# EPSON PRODUCT SUPPORT BULLETIN

**Date:** 06/10/2009  
**TIB #:** PSB.2009.06.002  
**Reference:** TI 09-08j Rev. A  
**Product(s):** PowerLite 735c / 737c / 745c / 755c / 765c / 835p / 1705/1715/1815/1825/7850p / 8300 with EasyMP.net option, Pro G5150/G5350 / 1725 / 1735W / 85 / 825 / 826W  
**Subject:** Release of EMP NS Connection for Windows & Mac Upgrade from v2.50 to v2.51

This bulletin was created to inform you of the release of the new version 2.51 of the EMP NS Connection software.

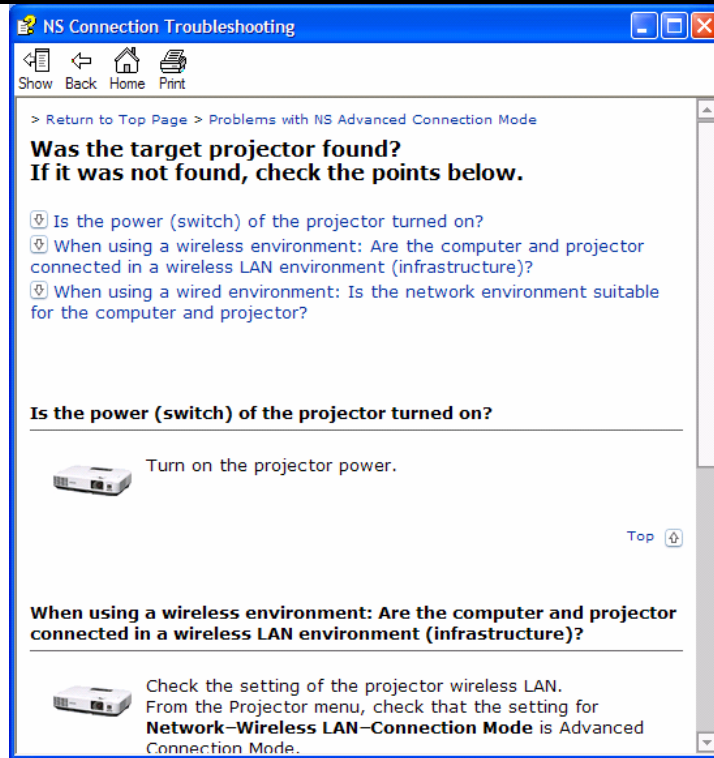
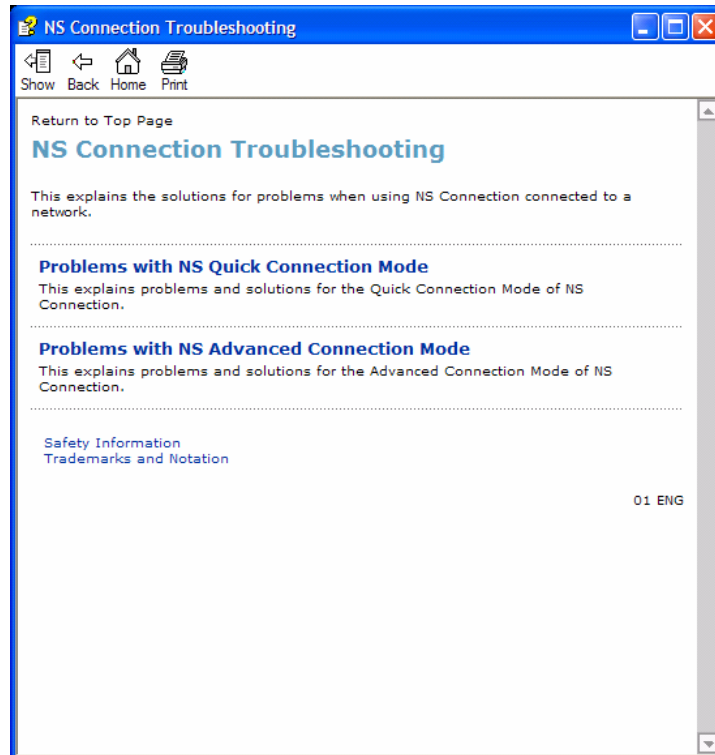
Improvements	<ul style="list-style-type: none"><li>■ Addition of 10 new languages: Arabic, Ukrainian, Romanian, Indonesian, Croat, Slovak, Bulgarian, Malay, Vietnamese and Hebrew.</li><li>■ Addition of troubleshooting function (Windows Only) When pressing the troubleshooting button, the corresponding troubleshooting and error number is displayed in the error message window.<ul style="list-style-type: none"><li>• When experiencing problems with NS Connect, please report to Epson the error number along with the failure information.</li></ul></li></ul>  
--------------	--

Also you can access troubleshooting by clicking **Start → All programs → EPSON Projector→EMP NS Connection→EMP NS Connection V2.51 Troubleshooting.**

EMP Monitor V4.30

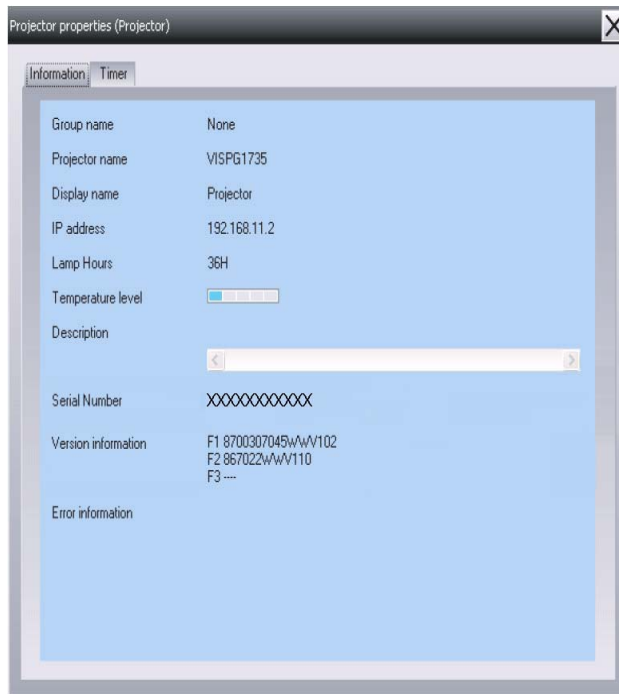
(2) Addition of Input Source (Only PowerLite 84 / 85 / 825 / 826W)  
Previous version of EMP Monitor included USB Display, USB and LAN as one source: EasyMP.

The input source buttons for USB display, USB, and LAN are available as separate input sources as shown below:
